Bid 638
New HVAC Modernization Project for Oxnard High School

BID CLARIFICATION ADDENDUM #1

Dated: November 01, 2020

Bid Clarification Addendum #1
Attachment A
Signet Controls RFI

DRAWING NUMBER: **10.1**

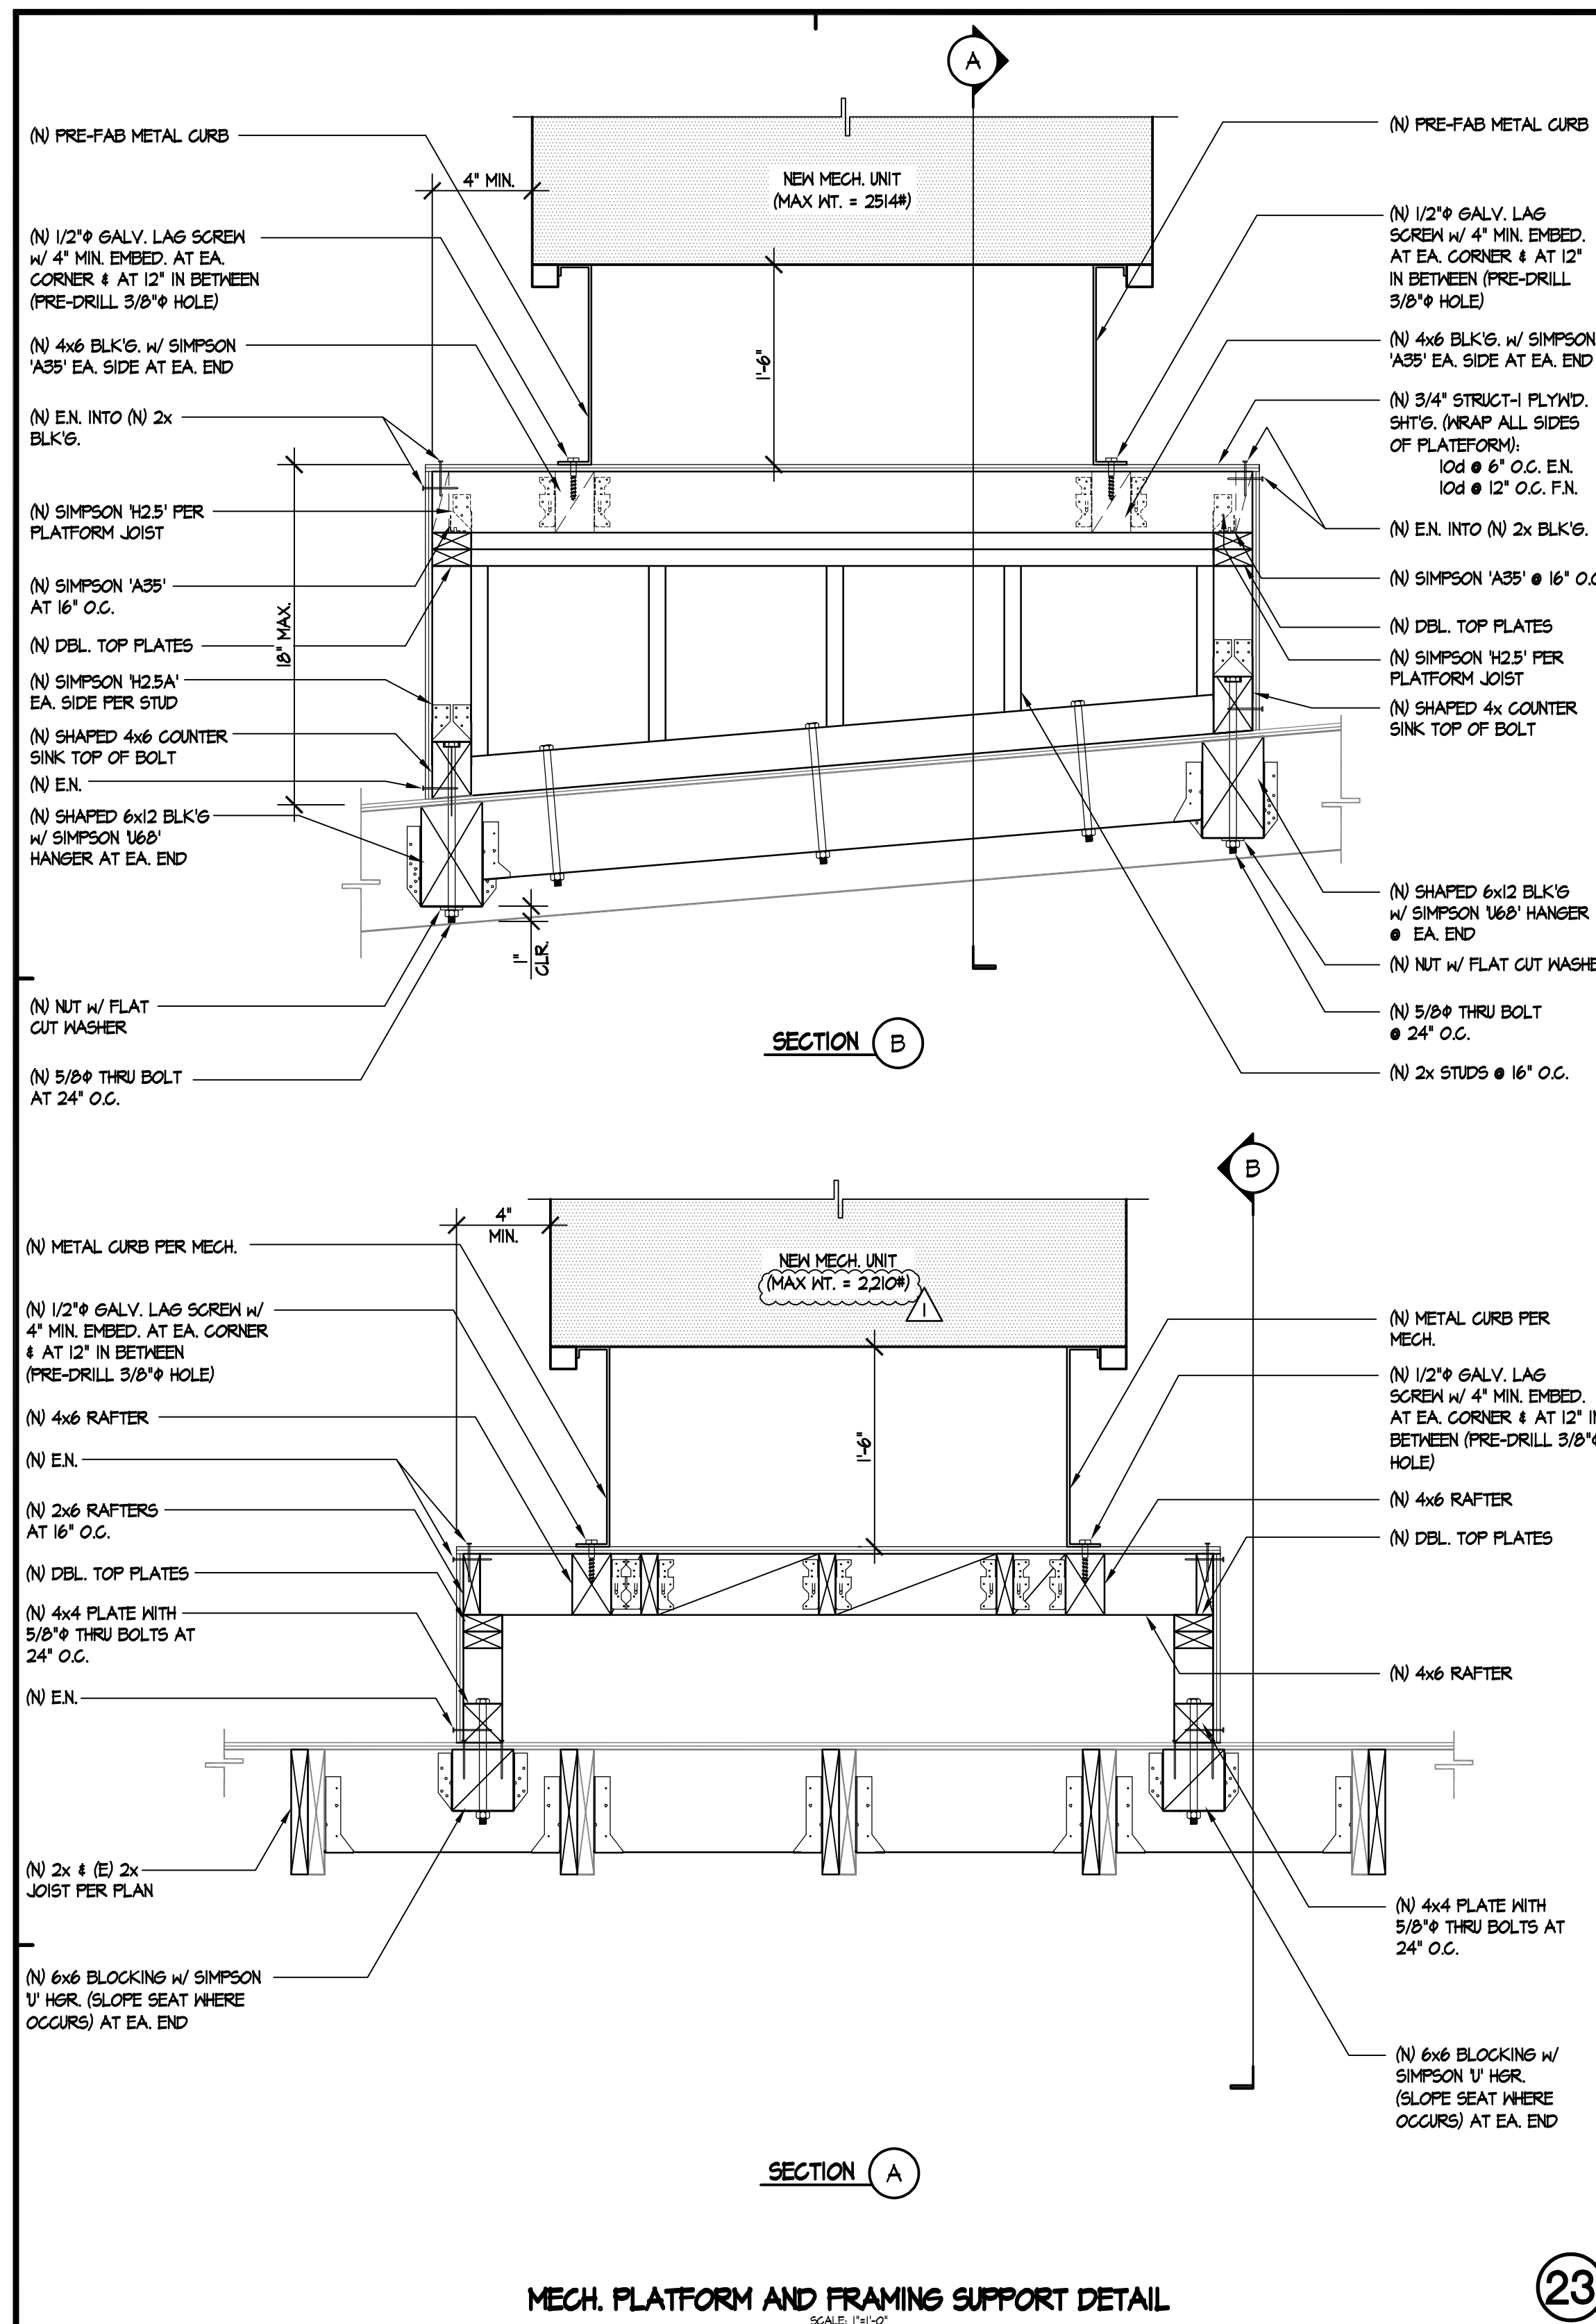
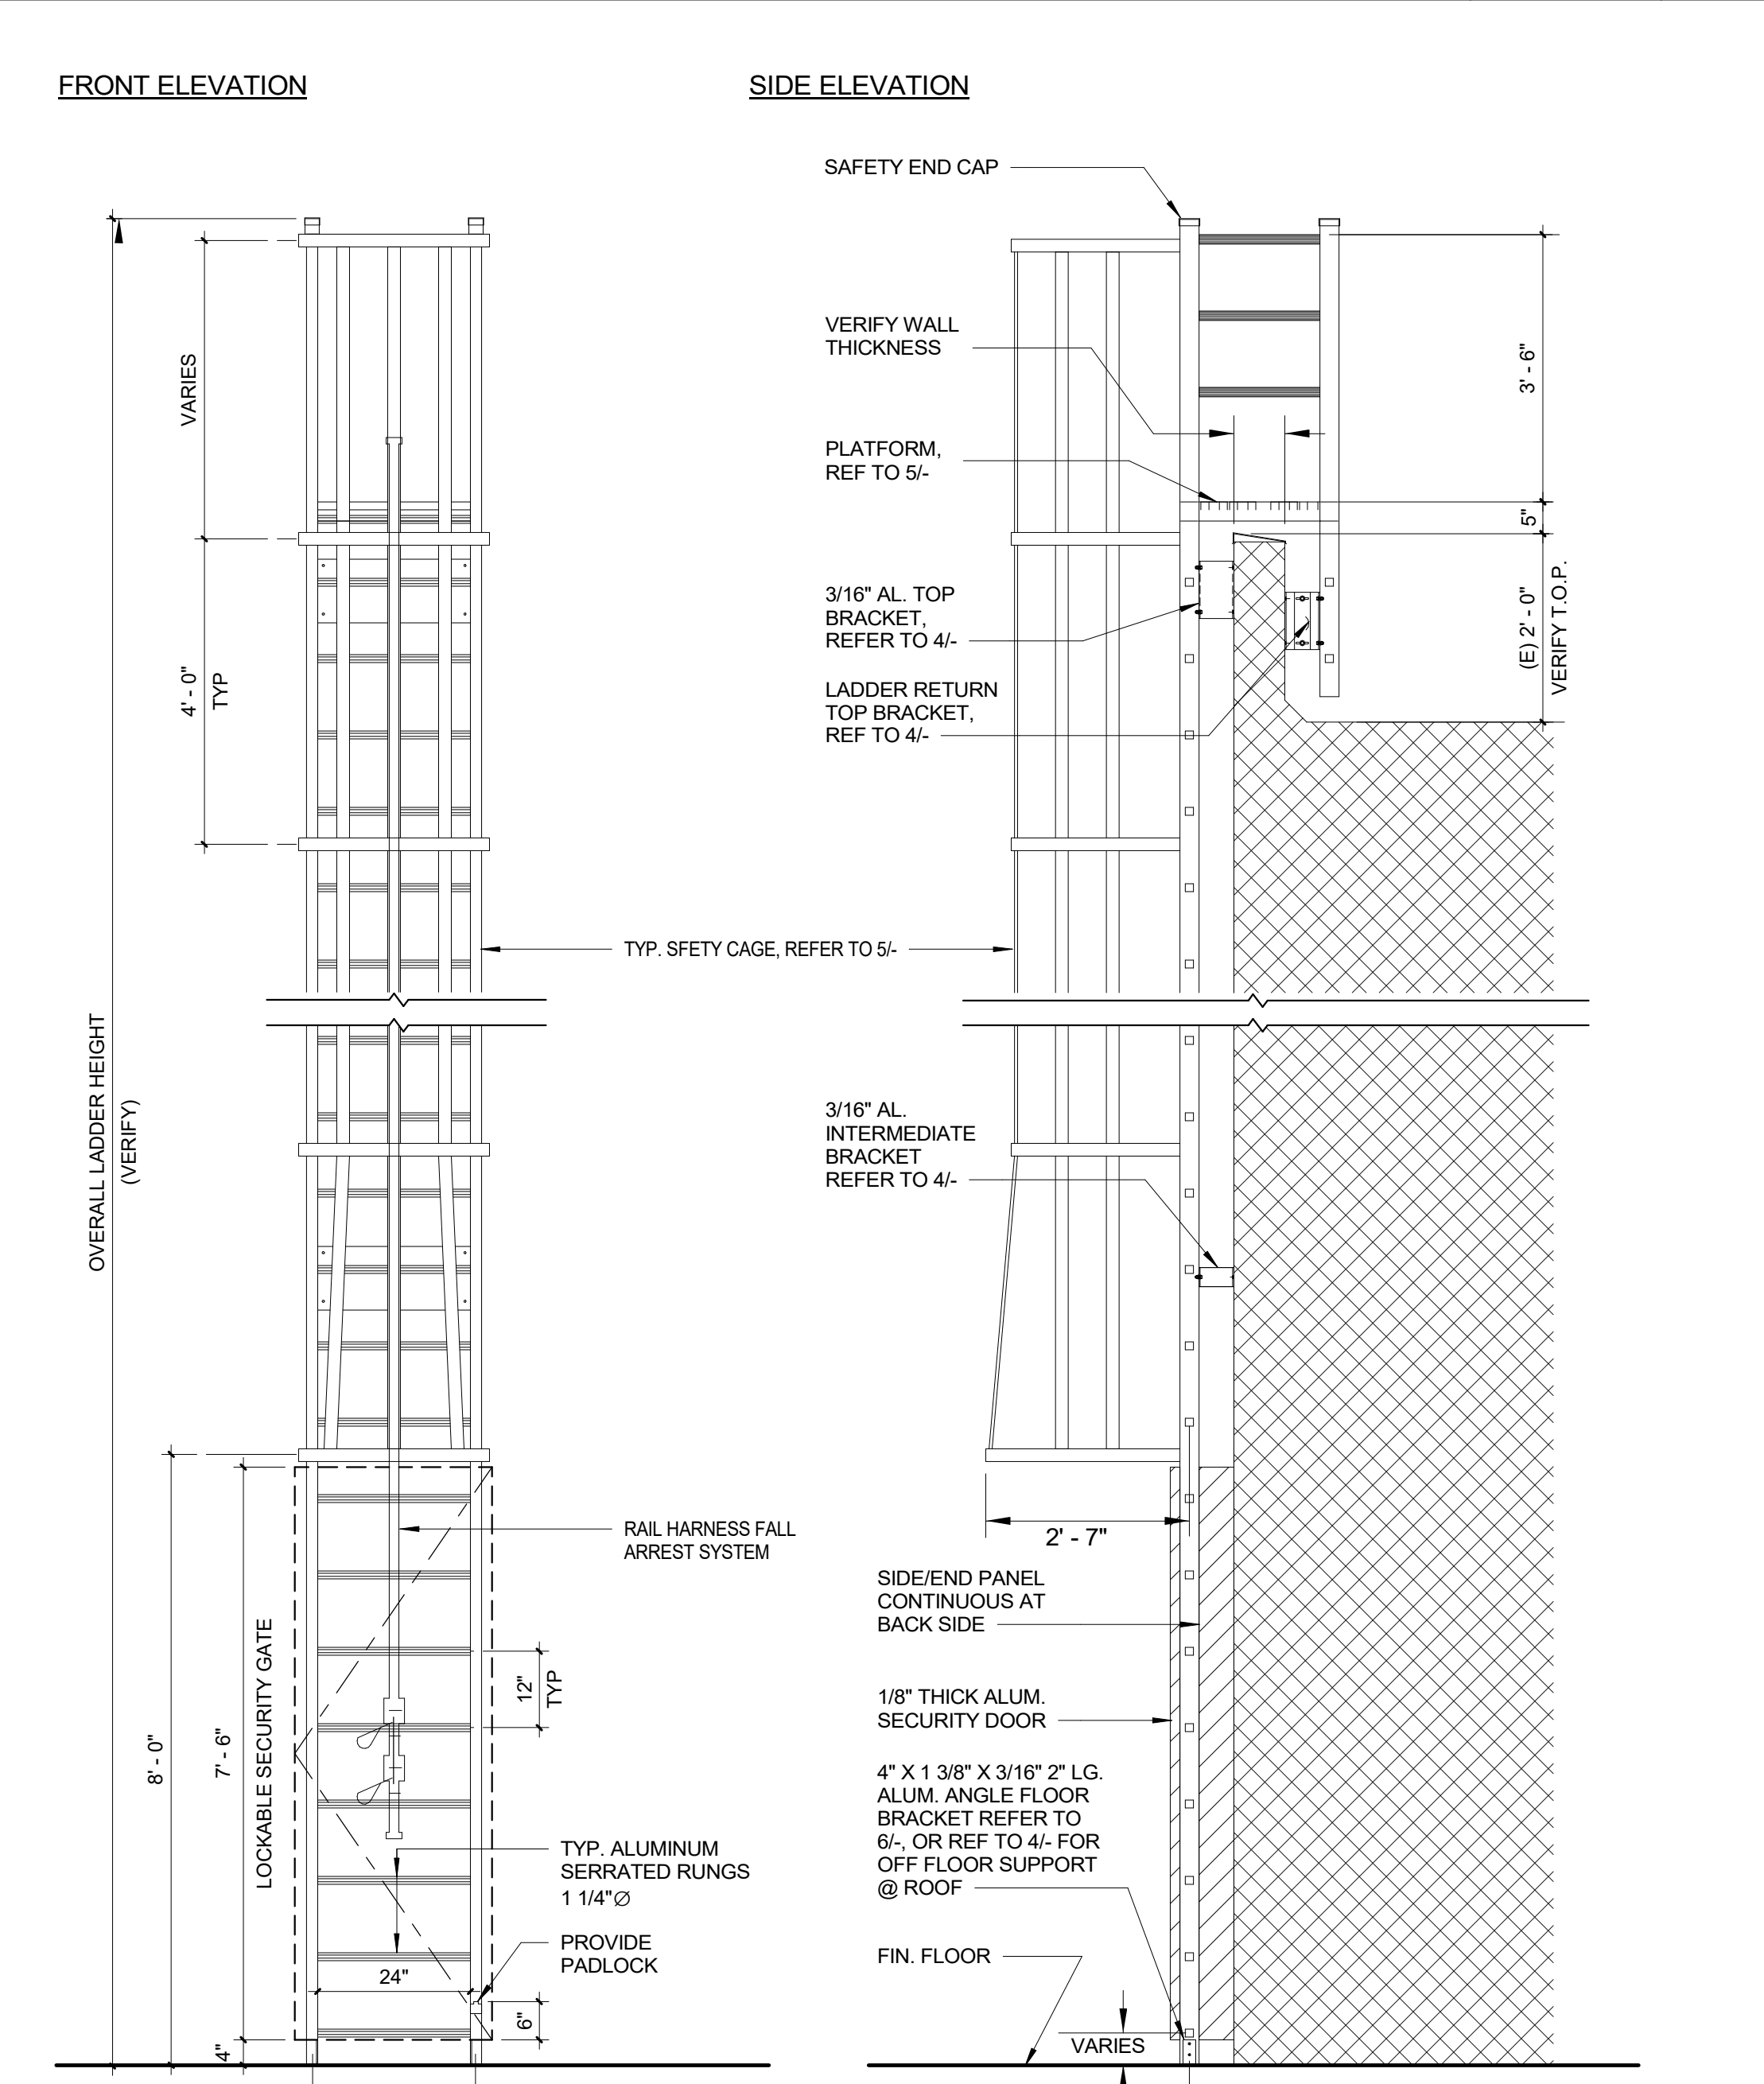
- A. Add the attached new Drawing 10.1 in its entirety.
